ADDENDUM NO. 3

Project Name: 11th Drive and 37th Street Roadway and Intersection Improvements

Bid Number: 2023009

SHEET NO.
25A

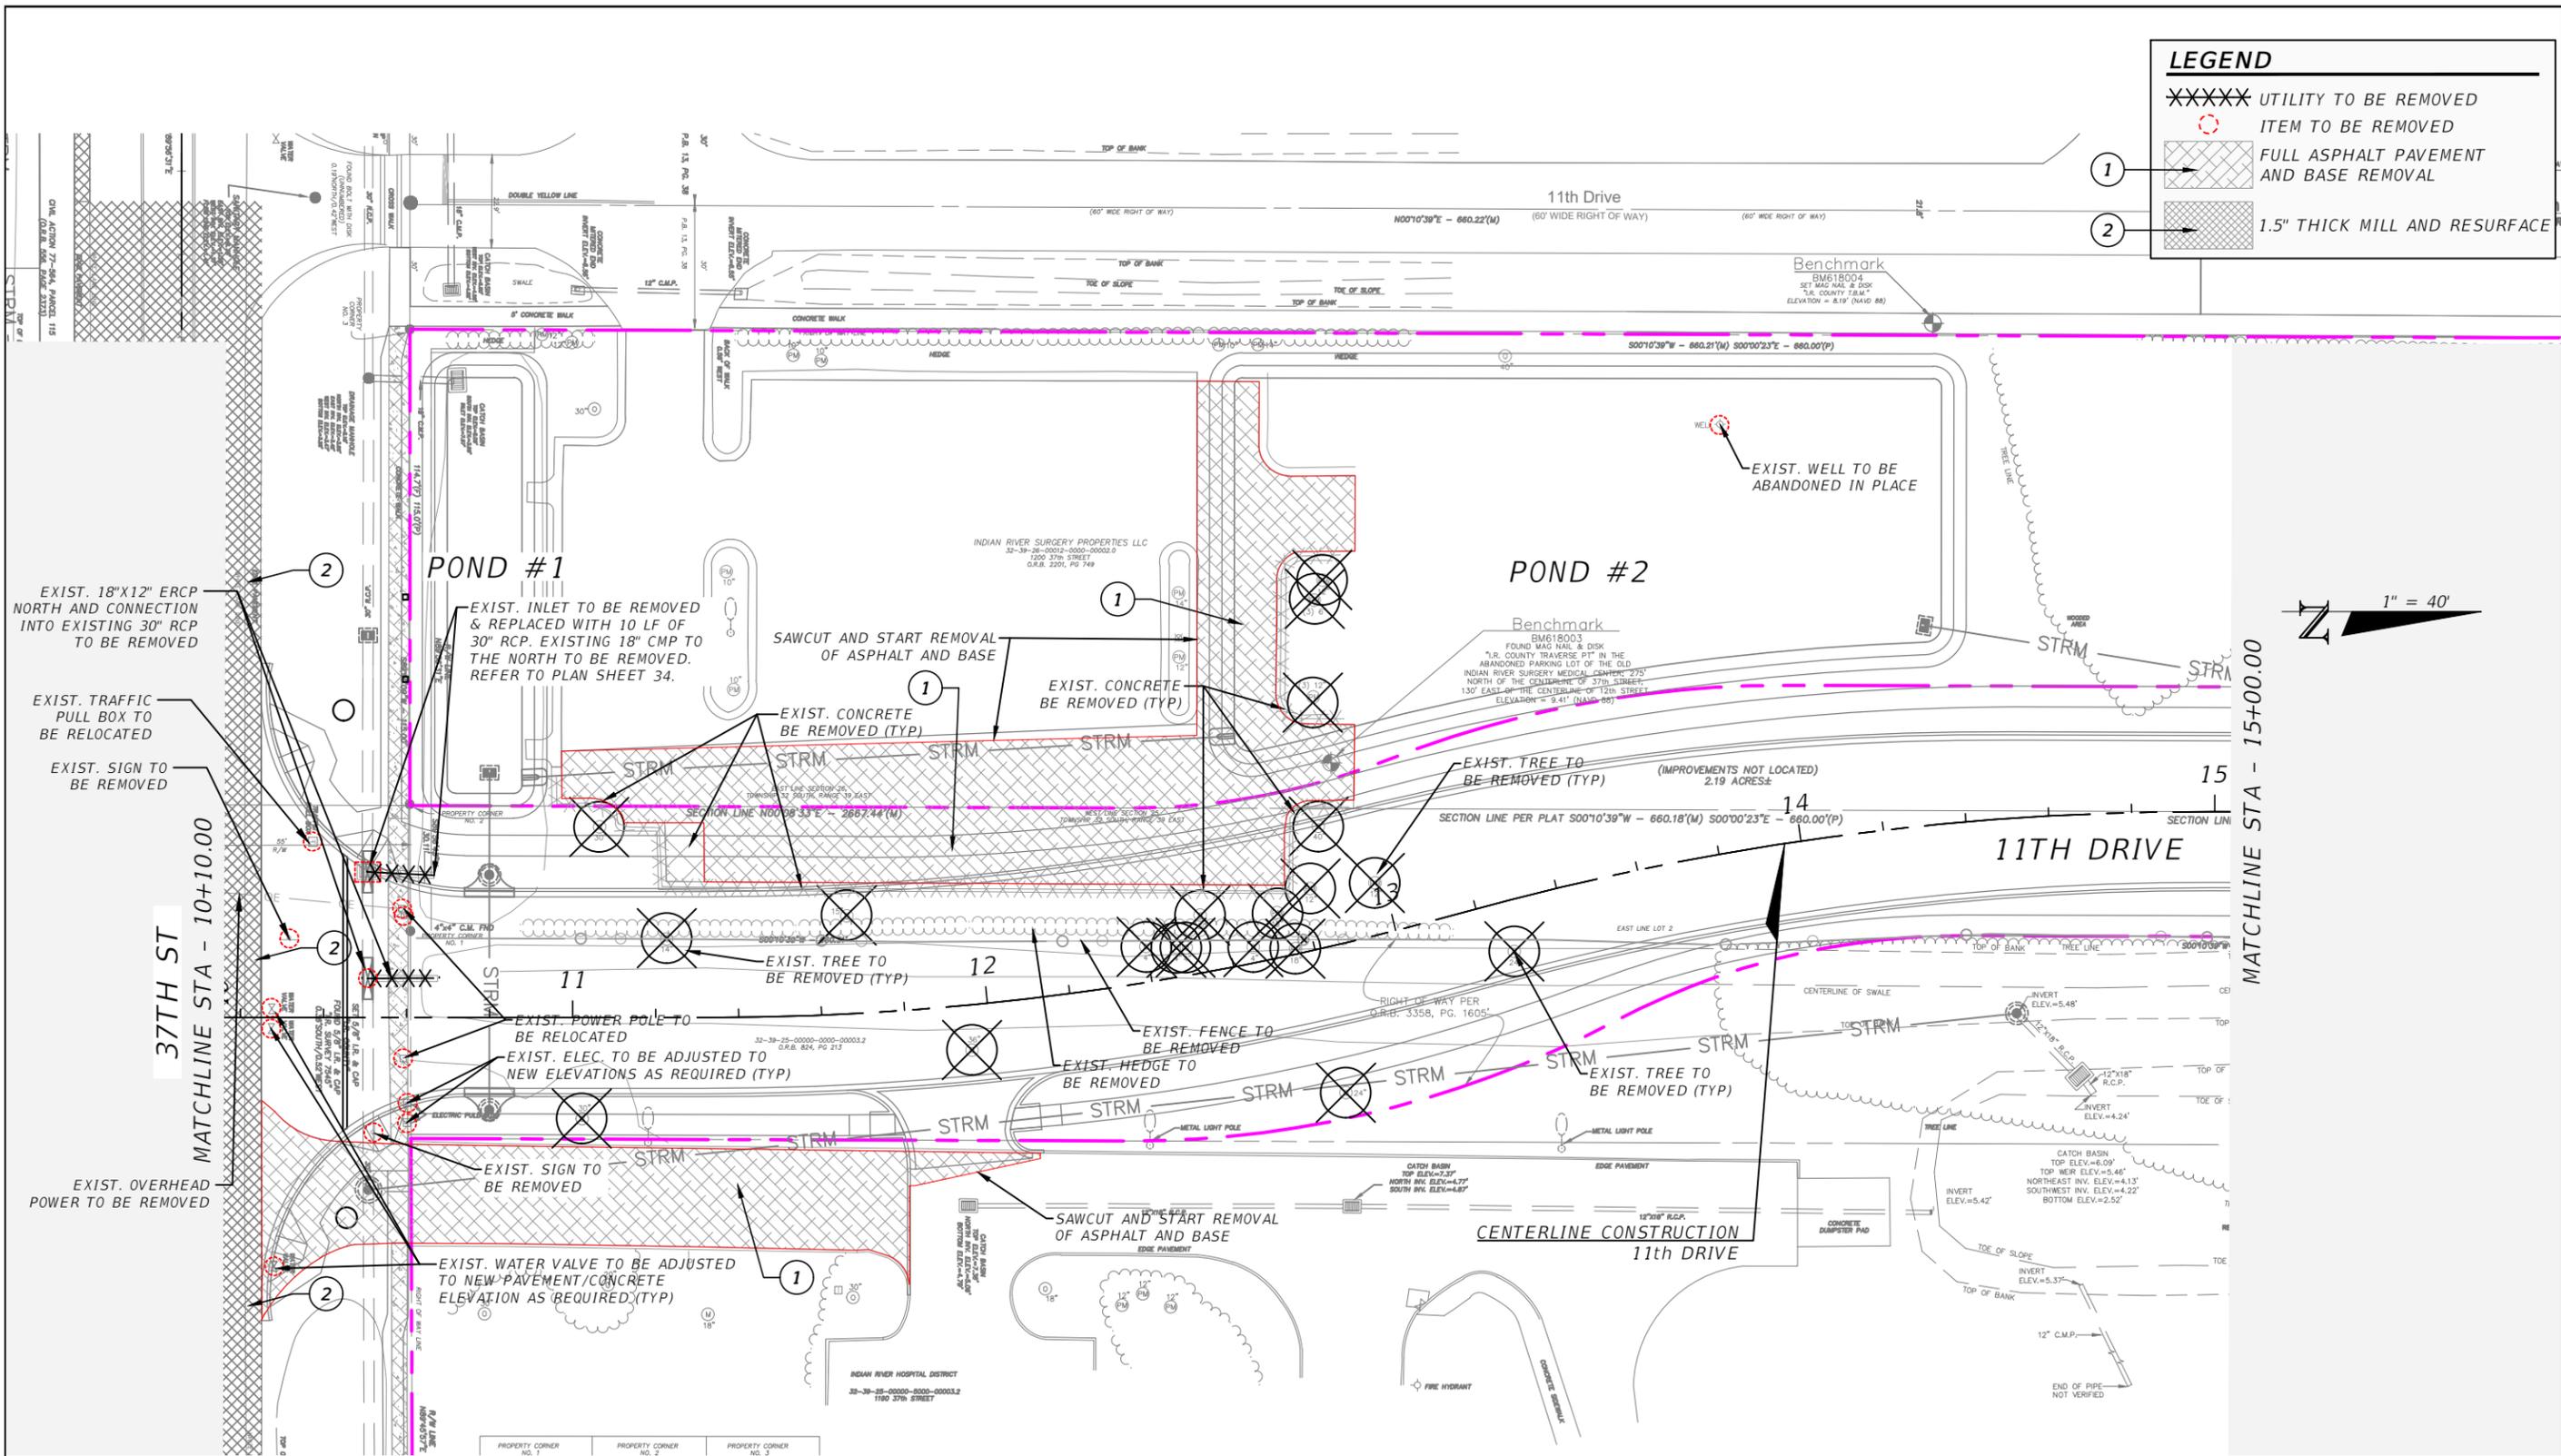
1. On Sheet 25 there is work that is cut off and not shown on any other page. Please provide an additional demo page for this cut off on the Northwest site of the project.
As an attachment, Sheet 25A has been created to include the area not previously shown.
